FUGRO WEST, INC.

August 5, 2004  
Project No. 609.004

Subject: February 2004 Work Plan Addendum, Additional Site Study  
2250 Telegraph Avenue, Oakland, California

**PROPOSED SAMPLING LOCATIONS 2004**  
2250 Telegraph Avenue  
Oakland, California

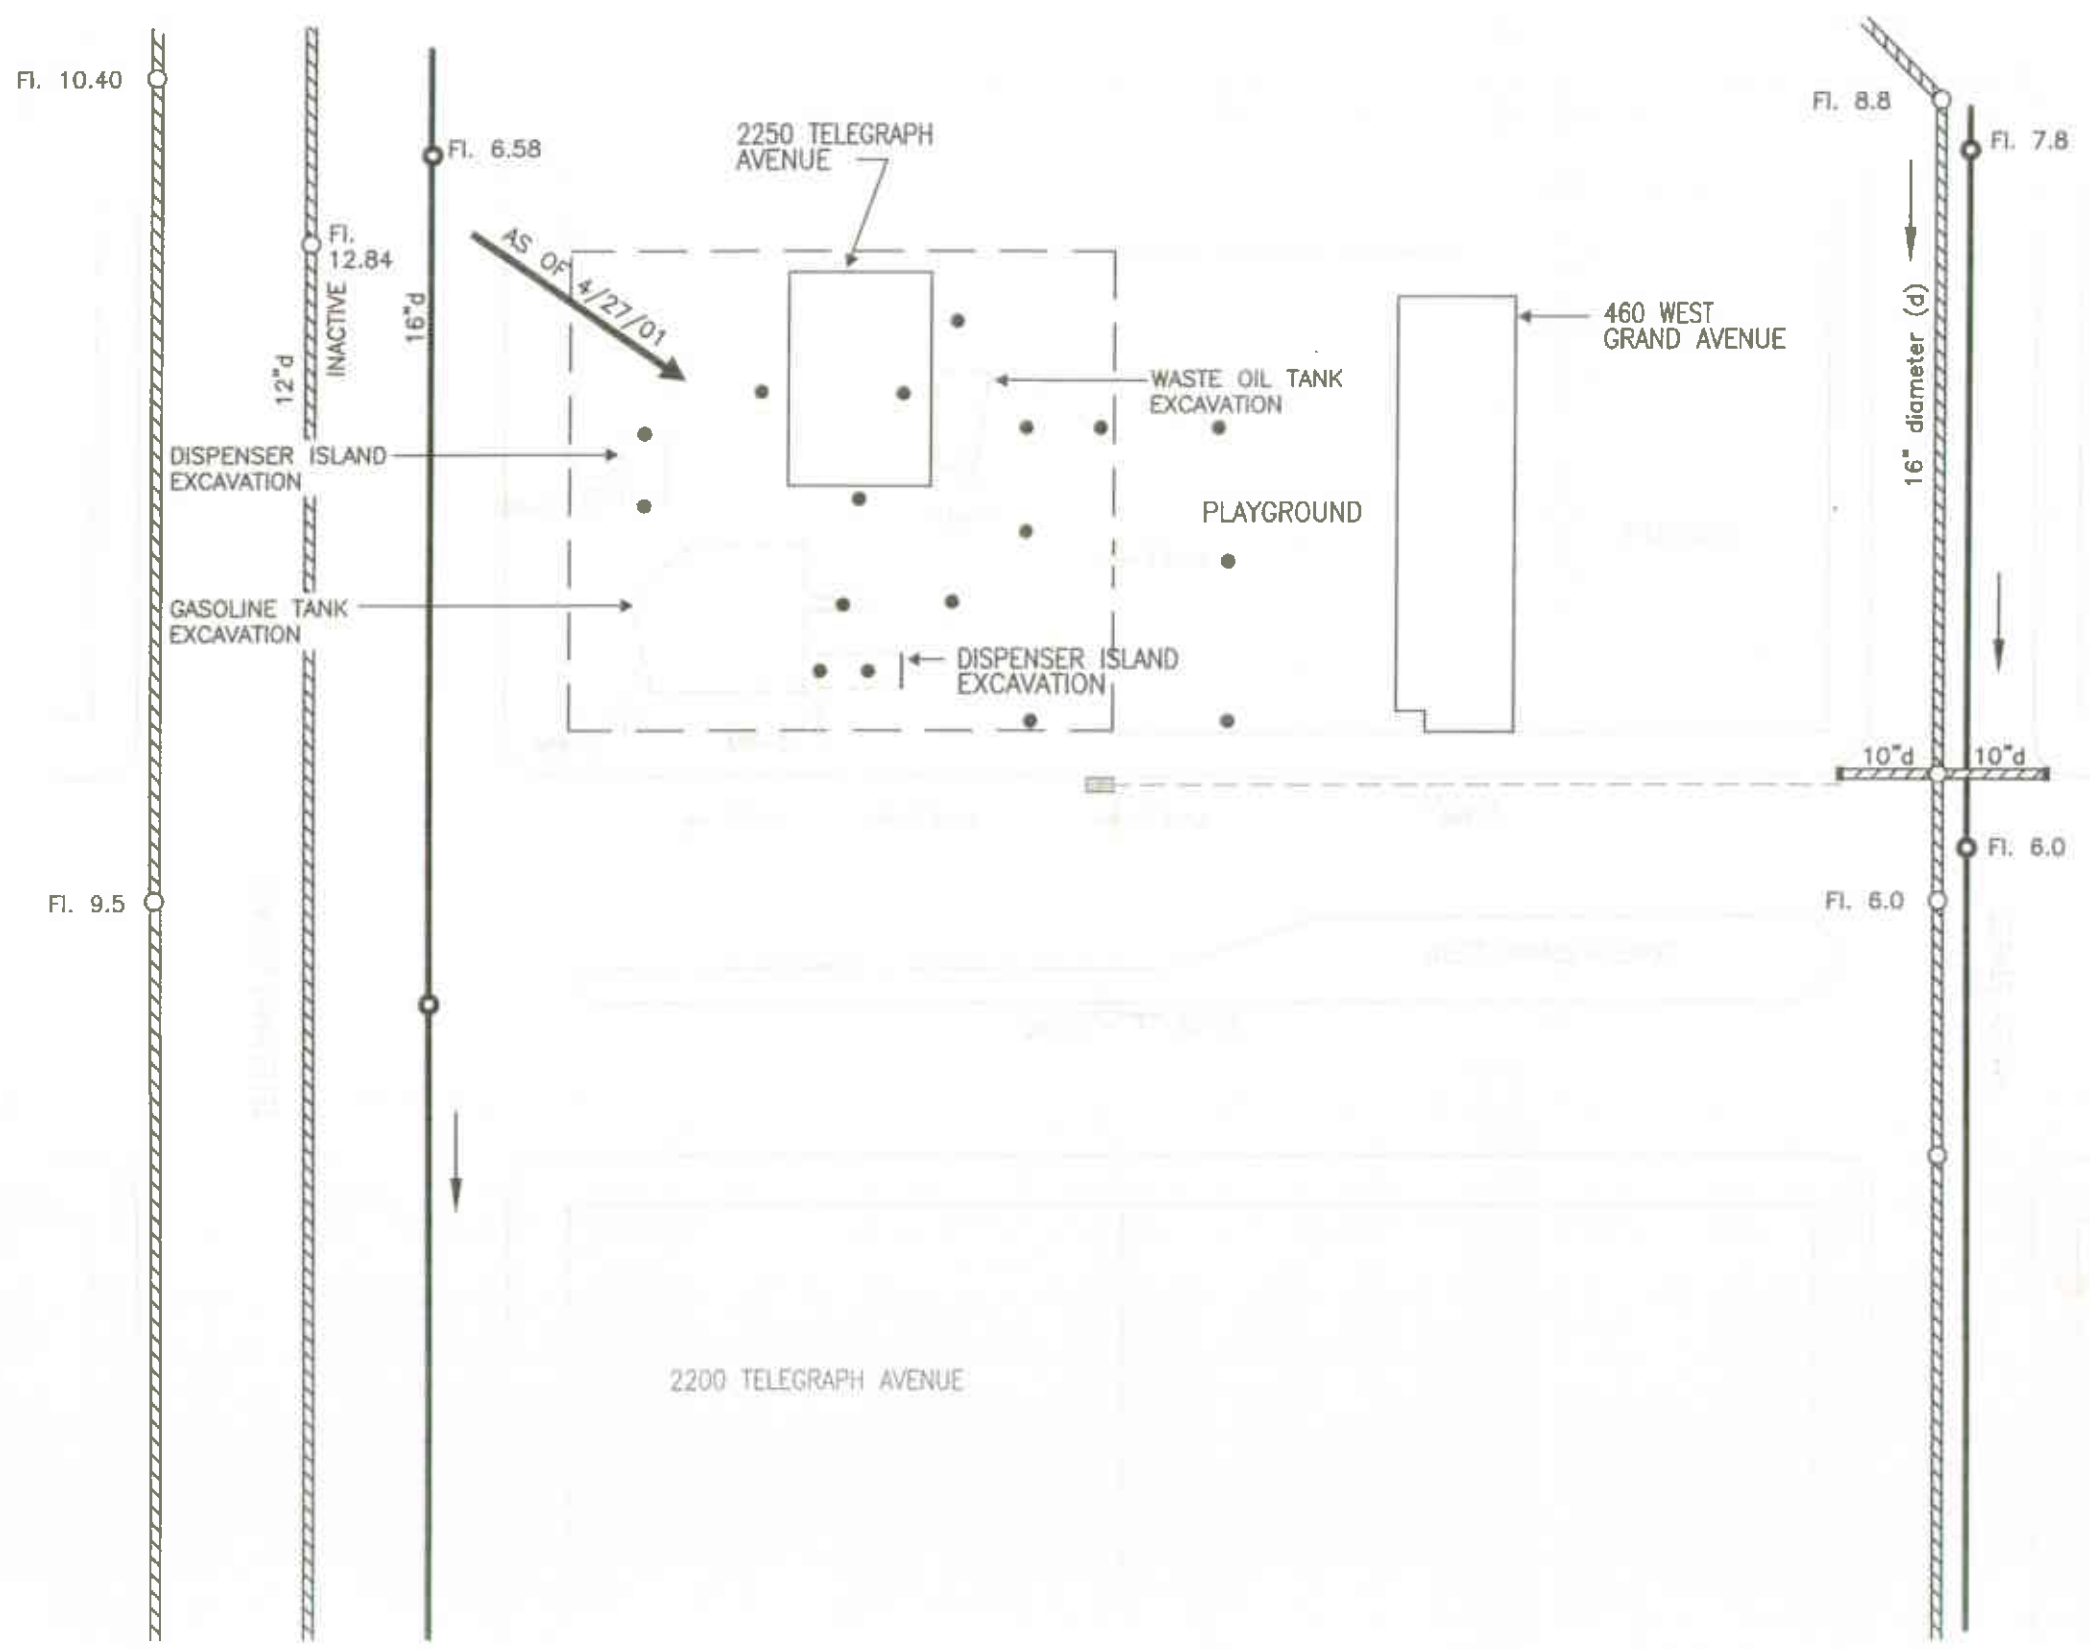
*... most of the sampling locations proposed appear to be suitable for groundwater sampling for site characterization. However, the proposed location near G12 maybe unnecessary since another location further downgradient is also proposed. Also, the proposed location north of the waste oil tank excavation may be moved southeast 20 feet. Include your proposal for collecting groundwater samples to define the lateral and vertical extent of the dissolved contaminant plumes in the Work Plan Addendum requested below.*

*We feel that soil sampling ought to be used for defining the source area prior to [soil vapor] sampling. Nevertheless, the locations proposed adjacent to the waste oil tank excavation can be used for this purpose. However, more sampling locations are required by the waste oil tank excavation as well as in the area of the dispenser islands. Include your proposal for soil sampling to define the lateral and vertical extent of soil contamination sampling in the in the Work Plan Addendum requested below.*

A few additional geoprobe locations will be installed to facilitate the collection of additional groundwater samples as deemed appropriate to provide characterization of the lateral extent of the contaminant plumes. The geoprobe samples and the collection of groundwater samples from the existing wells should be sufficient to characterize the contaminant plumes. The new probe locations are as shown on the attached revised Plate 5.

**Response:** The February 2004 Work Plan includes collection and analysis of one soil sample from the vadose zone from geoprobe holes co-located with the proposed soil vapor sampling locations and are presented in the attached revised Plate 5, as described in the response to Comment 1. In addition, soil samples will also be obtained from the dispenser island locations to complete the characterization of these two previous source areas. Up to two soil samples will be obtained from the dispenser area geoprobes. The proposed sample locations in the dispenser areas are shown on the revised Plate 5.
